Willy ZIMINSKY et al Appl. No. 10/821,975

AMENDMENTS TO THE DRAWINGS

REMARKS

Fig. 3 (PRIOR ART)

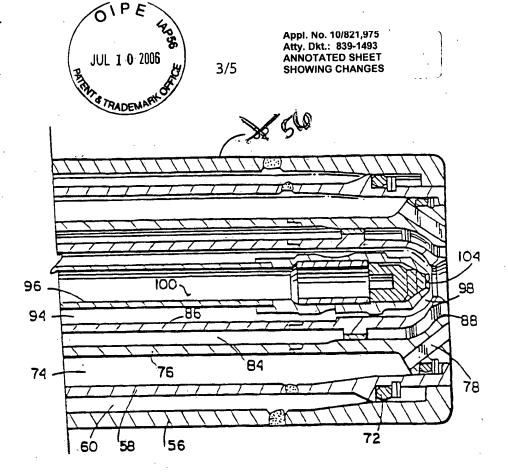
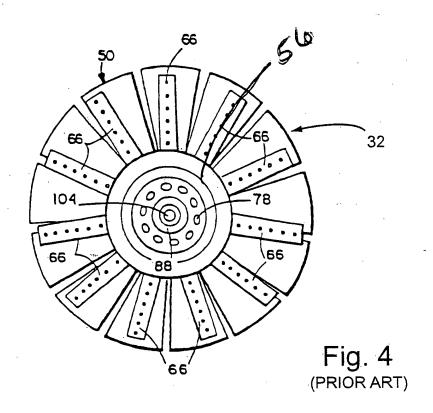
The attached sheet of drawings includes changes to Figures 3, 4 and 6. In amended

Figures 3 and 4, concentric tube 56 of a center fuel injector nozzle is properly labeled. In

Fig. 6

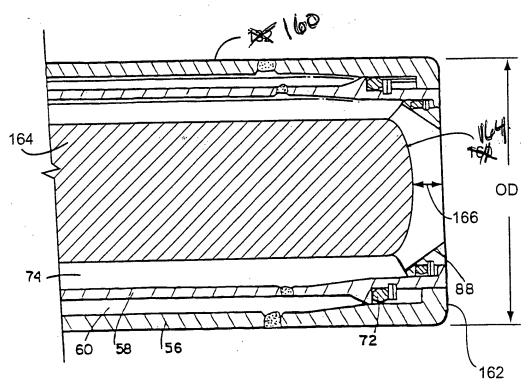
amended Figure 6, the bluff body is properly identified with reference numeral 160 (rather than

center fuel nozzle 132). No new subject matter has been added to this application.

The rejection of claim 4 as being indefinite is traversed because the disclosed embodiment shows a center nozzle having both a plurality of fuel nozzle outlets and a bluff body. For example, Figure 7 shows a center nozzle having a bluff body and fuel injectors on spokes 66. Figure 6 has been amended to properly identify the bluff body that is show in end view in Figure 7.
